BID ADDENDUM NO. 4

Date of Addendum: April 17, 2026
Issued for Bid Date: March 27, 2026
Client Name: Public Schools of the Tarrytowns
Project Name: 2024 Capital Bond Project – Phase 2; Washington Irving Intermediate School
SED Project No.: 66-04-01-03-0-002-017
TUFSD Bid Number: 25/26-TUFSD-003
MEMASI Project No.: 101-2403
Contracts: Contract 1: General Construction (GC)
Contract 2: Mechanical Construction (MC)
Contract 3: Electrical Construction (EC)
Contract 4: Plumbing Construction (PC)

6 SECTION AT STORMWATER PLANTER

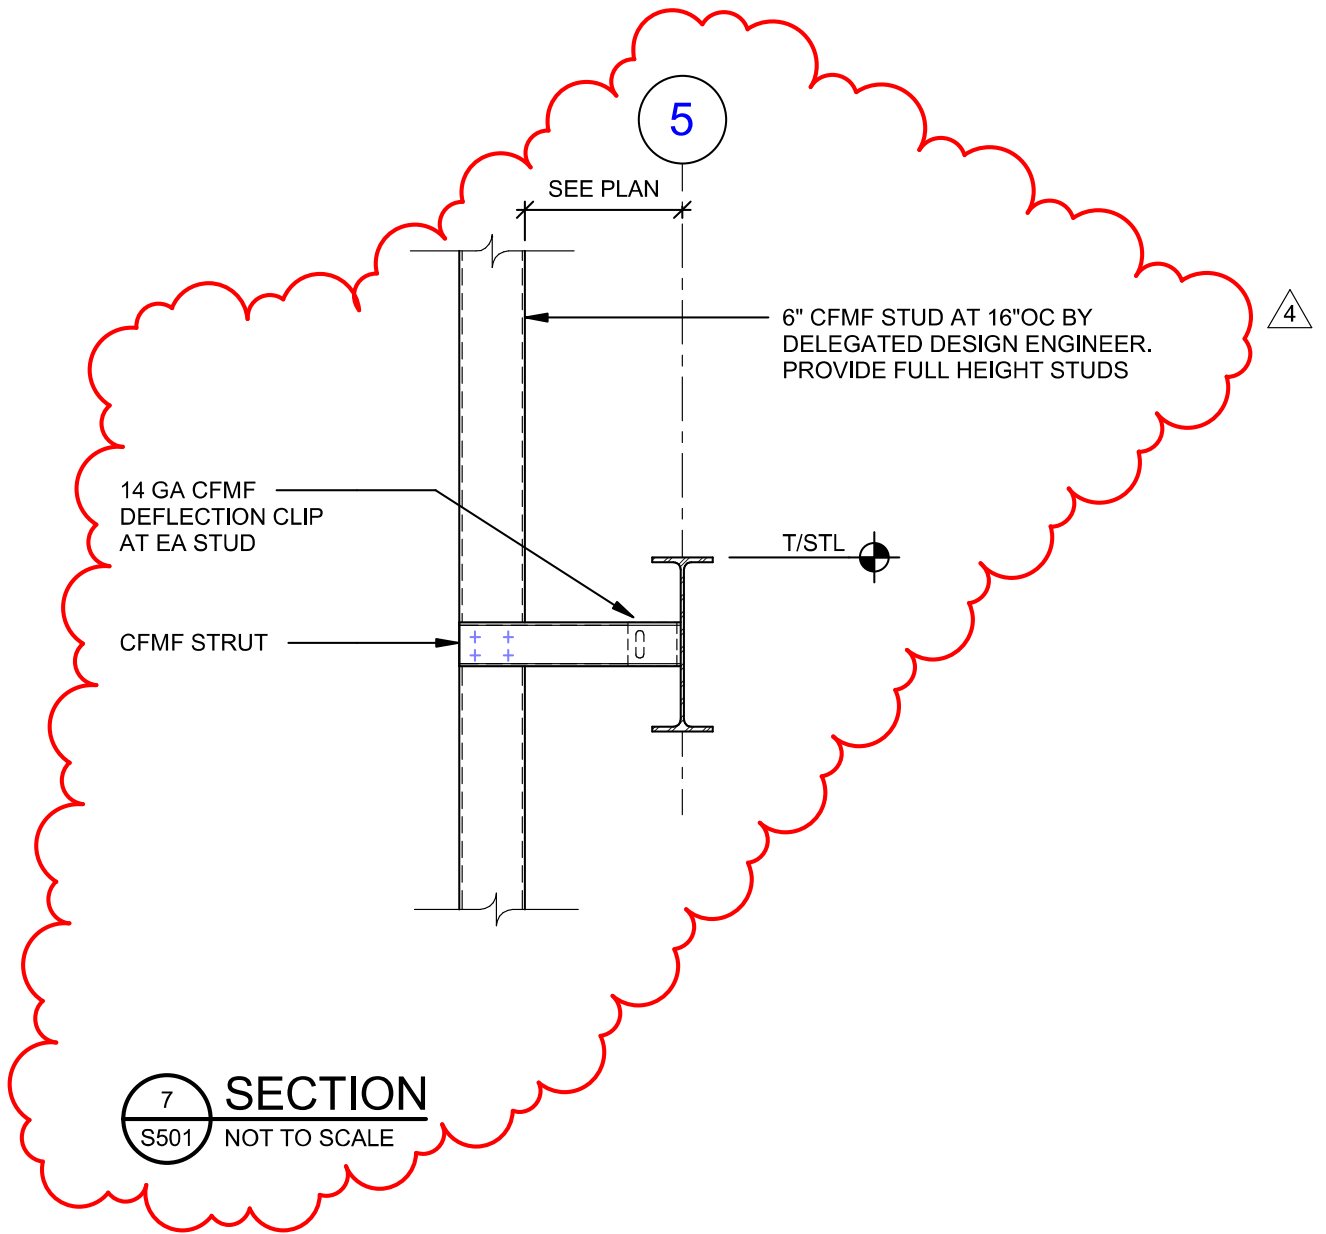
- r. SHEET S302 – CONCRETE SECTIONS AND DETAILS – REVISE existing detail 6/S302 with revisions shown on the attached sketches. Revised 4/17/2026, attached.

S501

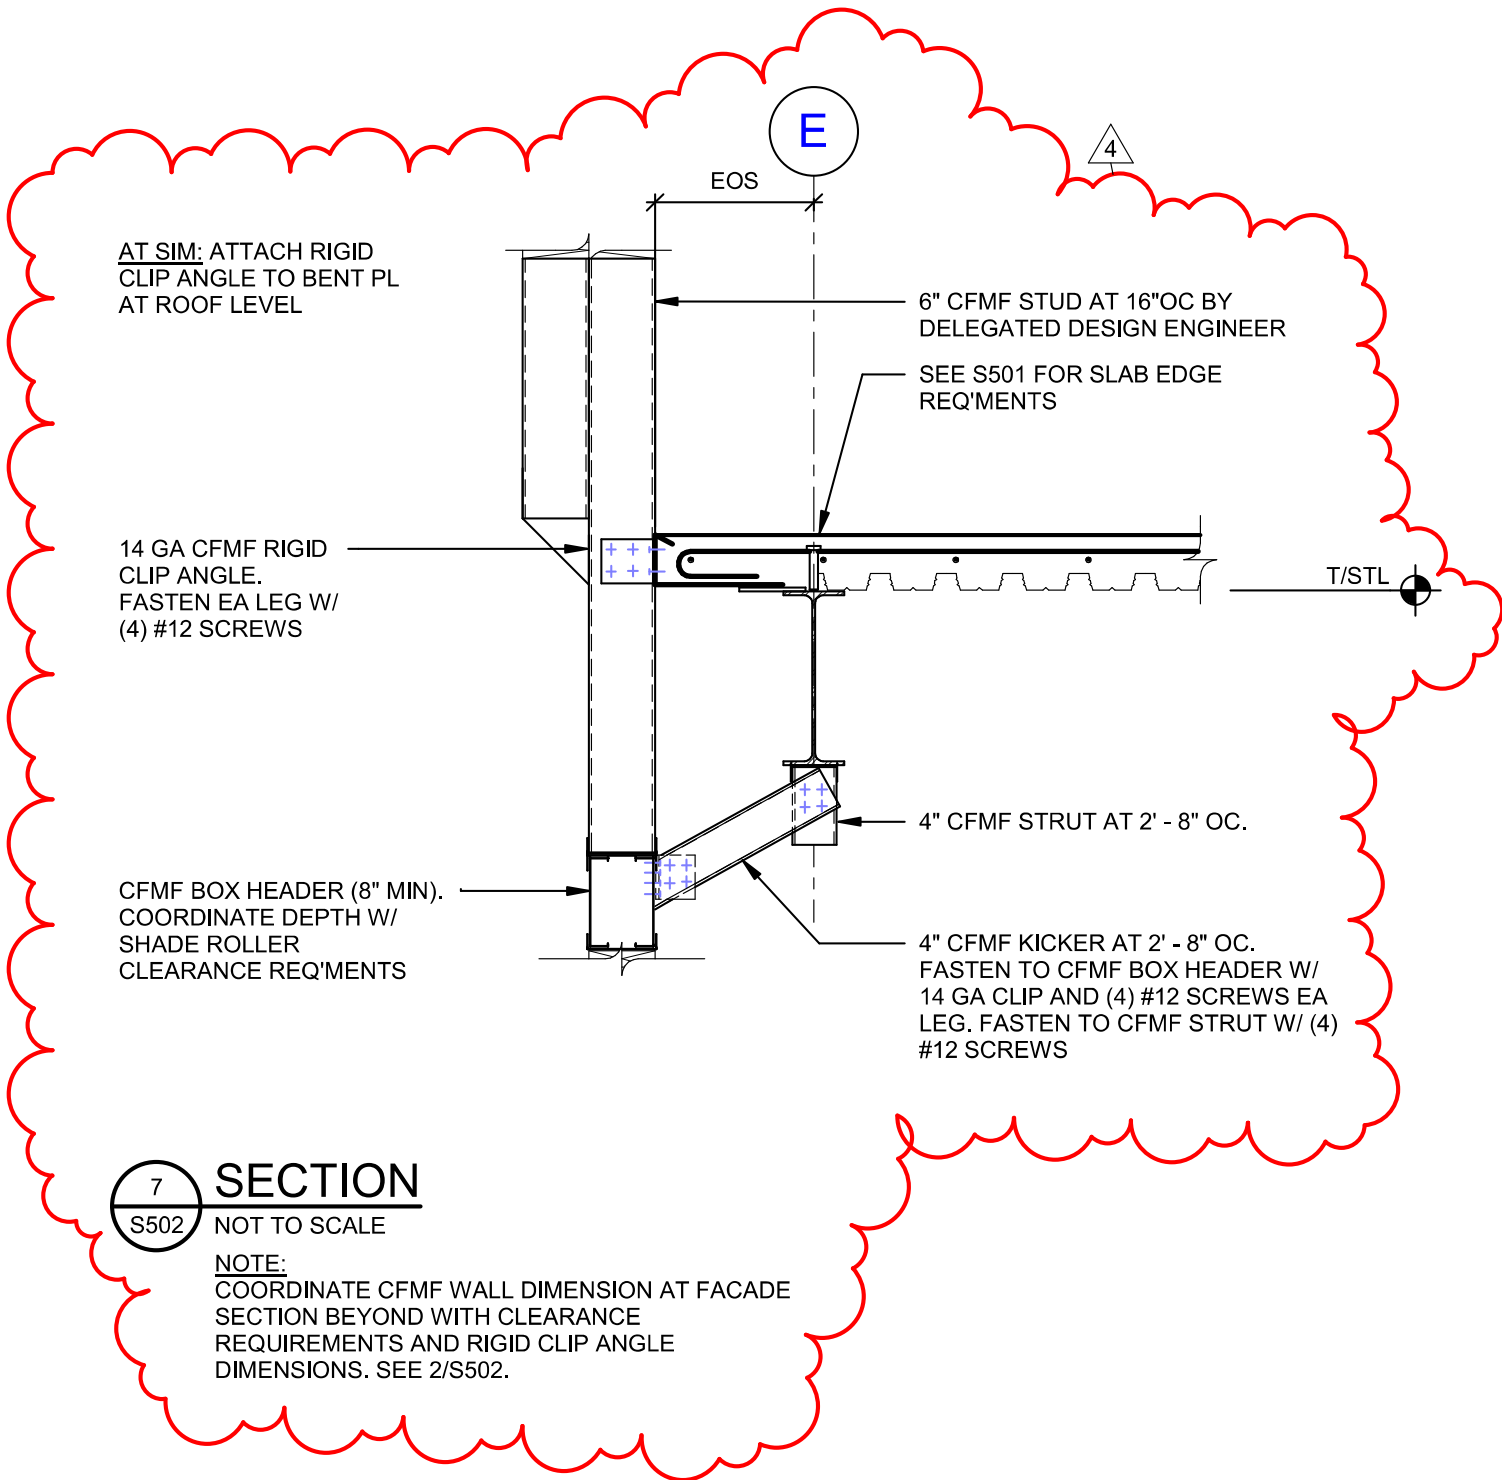
- s. SHEET S501 – STEEL SECTIONS AND DETAILS – ADD detail 7/S501, to existing sheet S501 with revisions shown on the attached sketches. Revised 4/17/2026, attached.
